TN14 RESPONSE TO FURTHER LHA COMMENT - EMPLOYMENT

VERSION	DATE	PROJECT NUMBER AND NAME	CREATED BY	REVIEWED BY
5.0	06.02.2025	23161 – Buntingford	JD	MG

3. LHA COMMENT AND RESPONSE

Appendix J Drawing showing roundabout access deflection

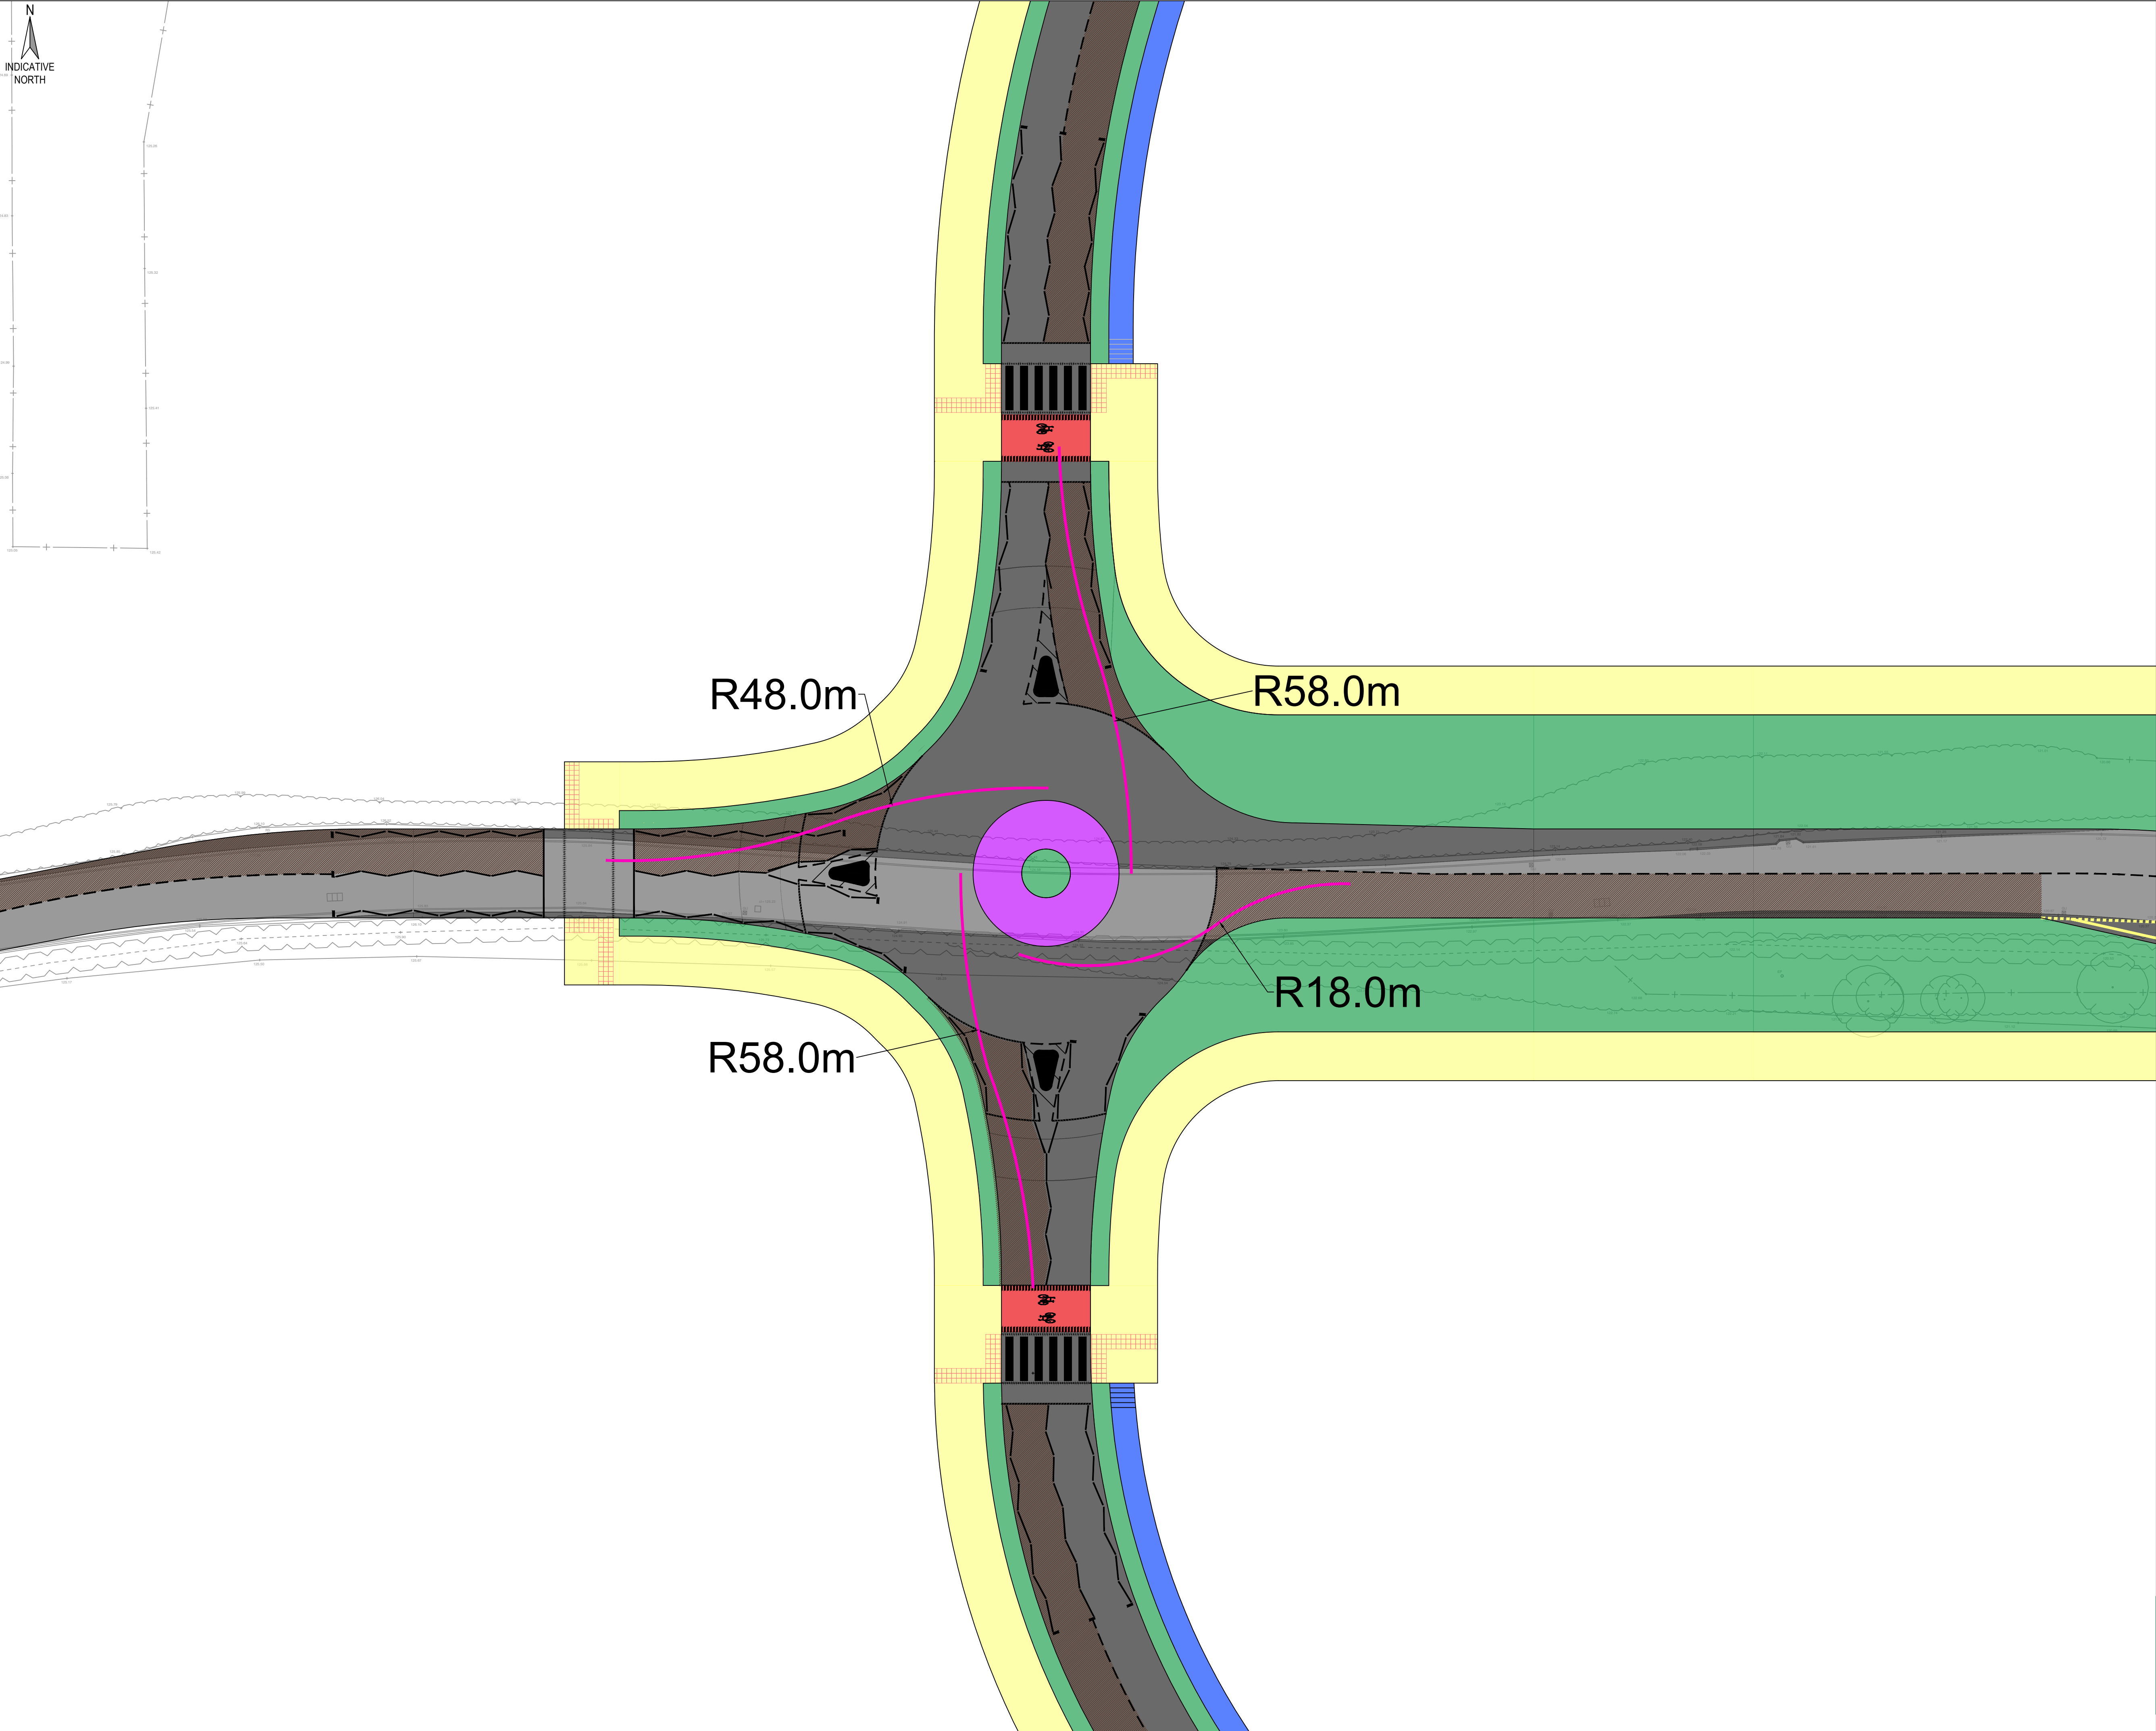
- Deflection on approaches to the site roundabout are considered insufficient, particularly those on the Baldock Road approaches, and will not encourage reduced speeds. Deflection should be in line with CD116.
- The crossing of the A507 should be located closer to the proposed bus stops on Baldock Road to encourage use of this mode.
- Given the higher speed nature of the A10 the crossing must be located at least 20m north of roundabout as required by DMRB CD116 and not the circa 12m currently shown.
- The location of the proposed southbound 60mph to 40mph speed limit change on the Northern A10 approach is too close to the Toucan crossing for vehicles to have slowed sufficiently by the time they reach it. Further, HCC RSA team comments are needed.

- Bullet 4 – A drawing setting out deflection is provided in **Appendix J**. This demonstrates that entry path radius does not exceed 70m on the identified key approaches in line with DMRB guidance document CD116 'Geometric design of roundabouts'.

- To note the central island has been adjusted to show a wider overrun area and smaller central island both in accordance with CD116. For consistency this change is shown both on the deflection drawing in **Appendix J** and also on the revised access plans (i.e. as shown in **Appendix E** and **Appendix F**).
